**E5070A-05B**

# **S E R V I C E                      N O T E**

## E5070A ENA Series Network Analyzer, 300 kHz to 3 GHz

**When a measurement trace or output power shows troubles between 1.3 GHz and 2.1 GHz, or in full frequency range, replace A1 module with the latest one (E5071-6x571), and update E5070A Operating System at the same time.**

Figure 1. Trace shows noise around 1.3 GHz to 2.1 GHz at preset setting.

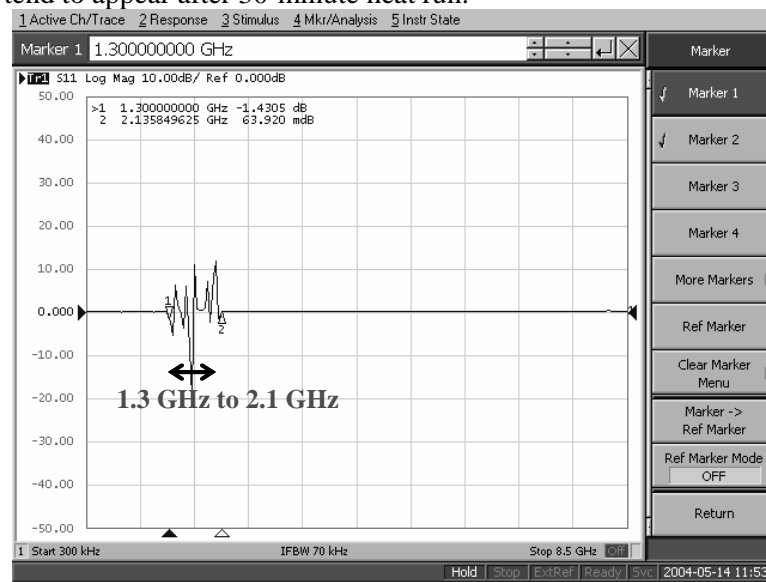
When the high-failure rate part has defective, the unit cannot output correct power level source or local signal, between 1.3 GHz and 2.1 GHz frequency range.

- The trace shows spike at 1.3 GHz or 2.1 GHz at the preset situation.
  - The trace between 1.3 GHz to 2.1 GHz is more noisy than other frequency ranges.
  - The power level of 1.3 GHz to 2.1 GHz is lower than other frequency ranges.
  - Internal test of A1 ALC shows fail at SOP (f=1.3G) or LOP (f=1.3G) as Figure 2.
- Above symptoms tend to appear after 30-minute heat run.

Update the E5070A operating system image referring to the service note E5070A-06B. Then, replace A1 module and perform the appropriate post repair procedures referring to the E5070A/E5071A service manual chapters 6 and 7.
